UNITED STATES PATENT AND TRADEMARK OFFICE

APPLICATION NO.	FILING DATE	FIRST NAMED INVENTOR	ATTORNEY DOCKET NO.	CONFIRMATION NO.
10/575,526	12/08/2006	Richard Spitz	10191/4608	9368
26646 7590 11/10/2009 KENYON & KENYON LLP ONE BROADWAY NEW YORK, NY 10004				
EXAMINER				
HSIEH, HSIN YI				
ART UNIT		PAPER NUMBER		
2811				
MAIL DATE		DELIVERY MODE		
11/10/2009		PAPER

Office Action Summary

DETAILED ACTION

A portion of Fig. 1 of Spitz et al. showing the trench and the outer area of base

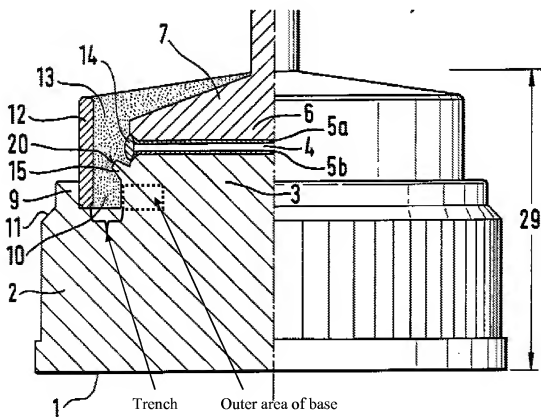
32. Regarding **claim 20**, Spitz et al. also teach the press-fit diode as recited in claim 17, wherein a trench (a portion of the trench 10 not occupied by the sheath 12) having a predetermined depth (see Fig. 1) is provided between the sleeve (12) and an outer area of the base (a portion of base 2 in contact with the right hand side of the trench 10; see the figure below).

A portion of Fig. 1 of Spitz et al. showing the first area and the second area

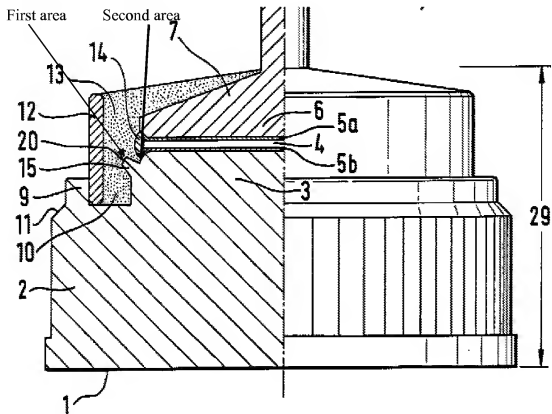
36. Regarding **claim 24**, Spitz et al. also teach the press-fit diode as recited in claim 17, wherein the base (2) includes an outer region (shoulder 15; Fig. 1, col. 3 line 37) having a first area (top area) with a first inner diameter (the diameter corresponds to the inner side of the shoulder 15 at the top) and a second area (lower area) with a second inner diameter (the diameter

corresponds to the inner side of the shoulder 15 at a lower position) smaller than the first inner diameter (see the figure below).
